### **MEMORANDUM**

**From:** Mary O'Neil, AICP, Senior Planner **RE**: ZP 14-0785CA; 438 Colchester Avenue

Request: Raise roof height 2 1/2 'to meet building code for head height on second floor. Add

NEW **ELEVATIONS**

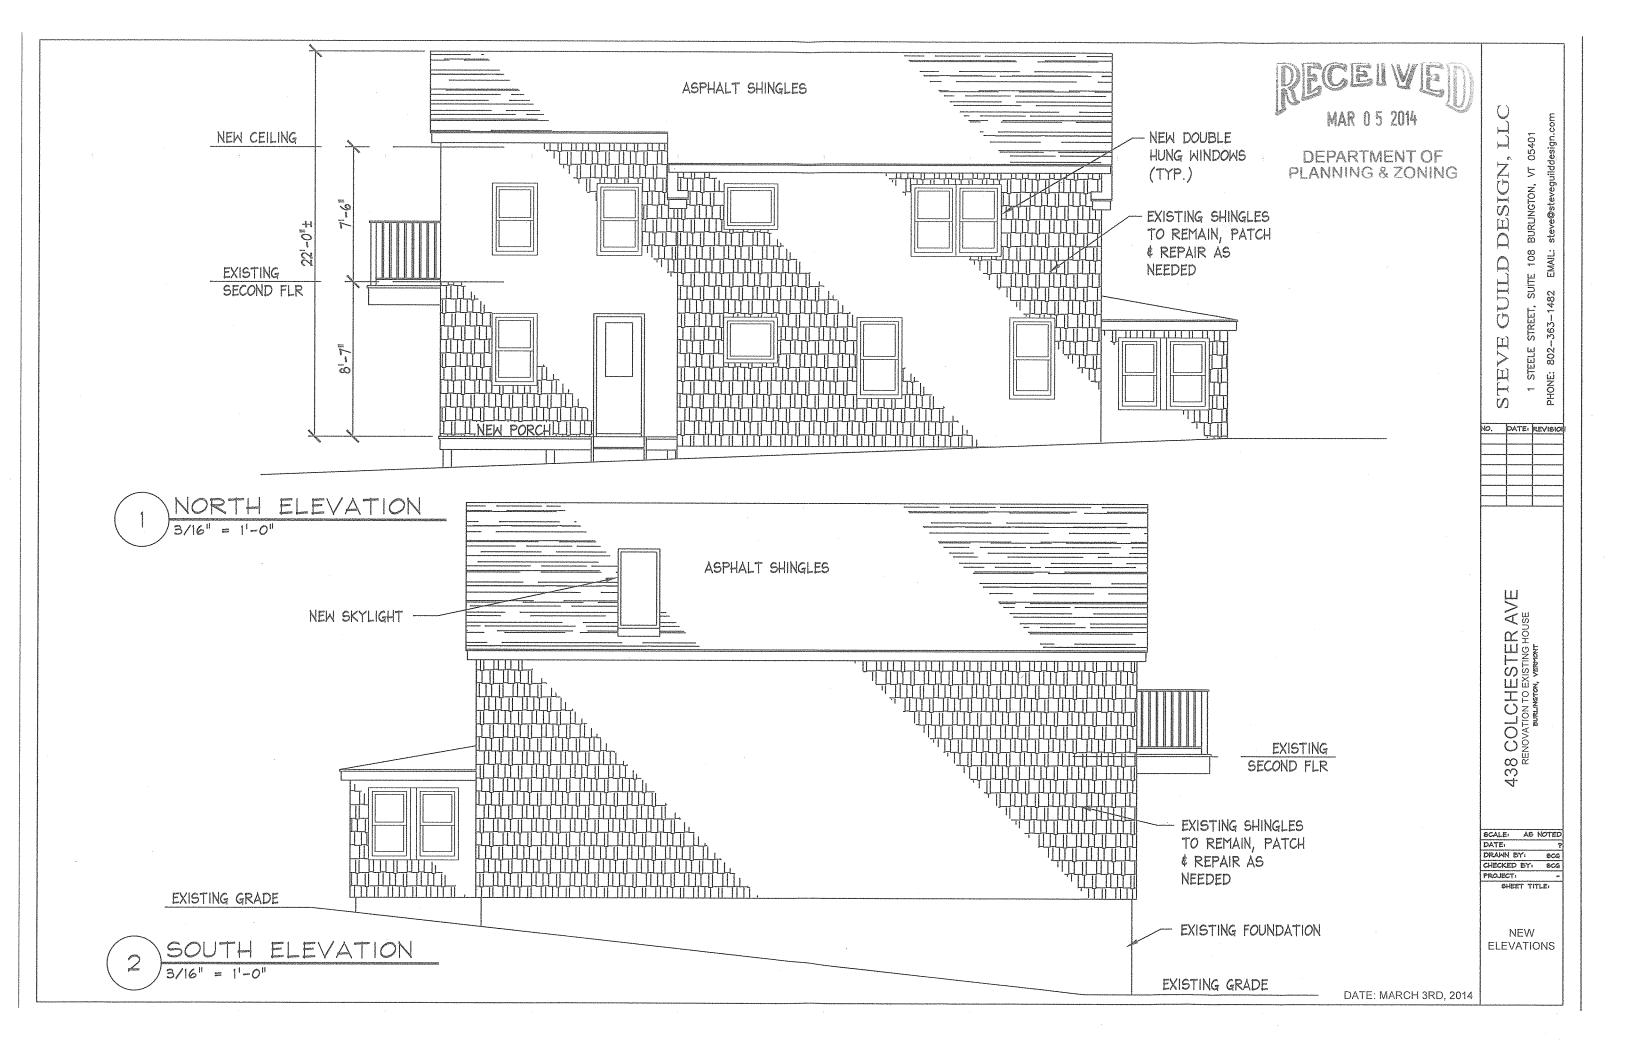
This is an existing 1 ½ story building that is proposed to have its roof raised 2 ½ feet

higher to accommodate headroom required by current code. The code implication became necessary because the applicant removed all interior walls and sheathing, so alteration from a building code perspective is viewed as "new construction."

The height change will not be noticeably different from the existing, but it will change the historic massing of the existing structure.

Window patterns are proposed to be replicated, although in a higher location on the 2<sup>nd</sup> floor due to the proposed roof change. The rear is illustrated with a new door onto a deck; this is a secondary façade, where greater flexibility may be exercised.

- If the DAB determines that the existing structure merits review as a historic building, then the proposal to raise the roof conflicts with this standard as it will change the spatial relationships and massing of the existing building.

- As proposed, the new (raised) roof may be considered irreversible.

If the DAB determines that sufficient integrity remains to consider the property an historic resource worthy of preservation, then all the standards of Section 5.4.8 will apply, including retention of the existing roofline (even if it will result in the loss of 2<sup>nd</sup> floor living space.) Vinyl windows are never considered acceptable replacements for historic structures, nor highly durable building material of quality under Section 6.3.2. (d).

- 2. The side porch should have a roof cover/canopy to protect residents from inclement weather.
- 3. Floodlights are not acceptable in residential settings. A full cut-off light fixture will be required, or a directed light with baffling to prevent light spill, activated on a motion sensor. Spec sheets must be submitted to staff for review and approval.
